**FIRLOUGH WIND FARM, CO. MAYO
AND
HYDROGEN PLANT, CO. SLIGO**

**RESPONSE TO THIRD PARTY SUBMISSIONS AND
OBSERVATIONS
PLANNING APPLICATION REFERENCE ABP-317560-23**

PROJECT	Firlough Wind Farm and Hydrogen Plant	
CLIENT / JOB NO	Mercury Renewables (Carrowleagh) Limited	6129
DOCUMENT TITLE	Response to Submissions Received

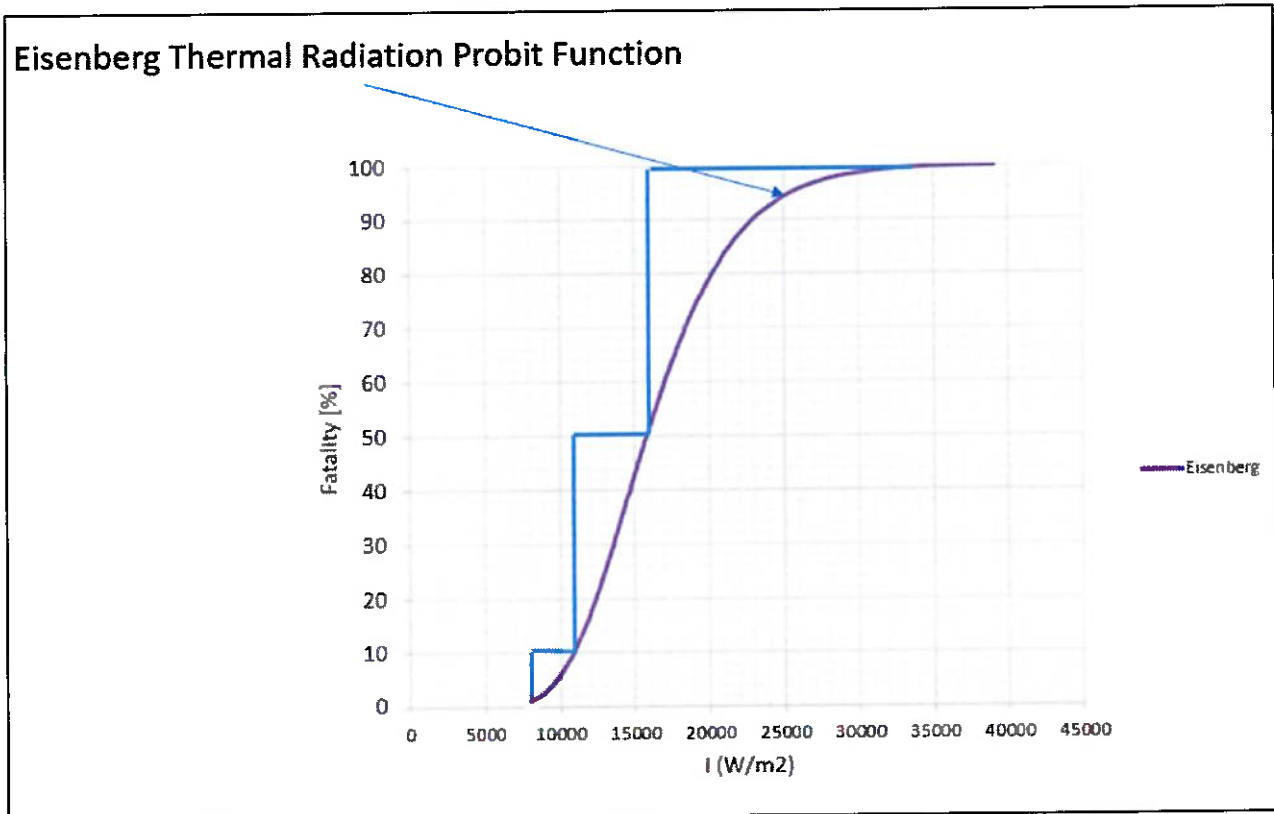
"b. Indoor fixed installations

i. The frequency of jet fire for 10 mm pipe leak is two orders of magnitude lower than that stated against Event# 079 in Table 37 of the TLUP Methodology, to be corrected."

3b i. This is a typographical error in the assumptions register. Please refer to Appendix C of the QRA report, which shows all scenarios modelled and the associated frequencies. Here it can be seen that the jet fire frequency for 10 mm leak is as per the HSA guidance document. The tables in the assumptions registers will be updated to reflect HSA guidance (and those applied in the QRA model).

Figure 3.1: Consultation Distance and Inner Risk Zones

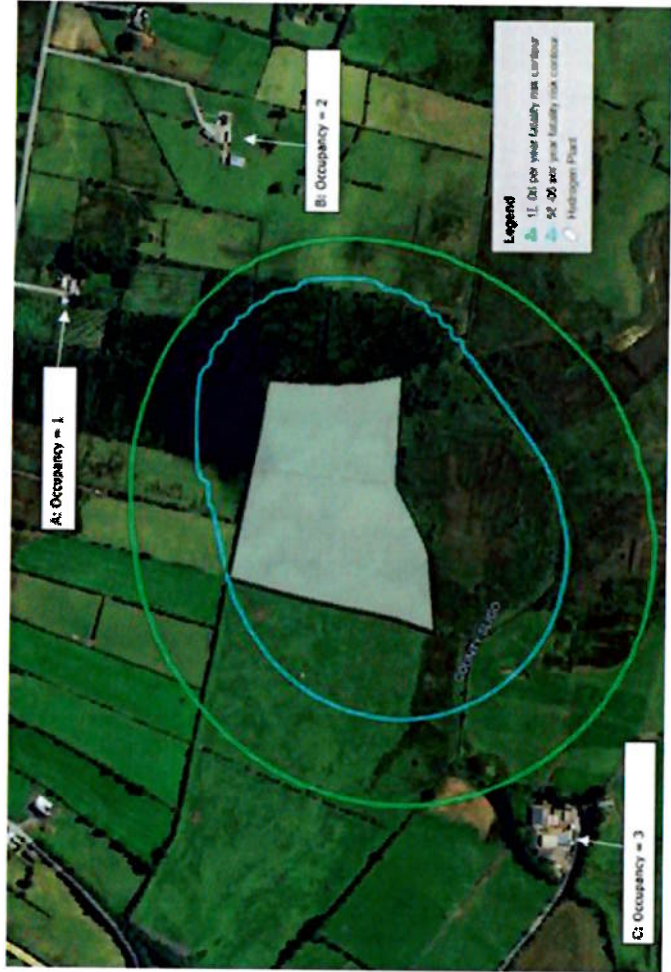
"7. Appendix D: The overpressure values presented are not consistent with those set out in section 2.4 of the TLUP, review and amend or provide justification for differing over pressure values."

The overpressure values in Appendix D of the QRA have been updated to those values provided in the TLUP guidance document. This does not change the overall conclusions of the QRA. The updates have an insignificant impact on contours, **see Figures 3.1 and 3.2** above.
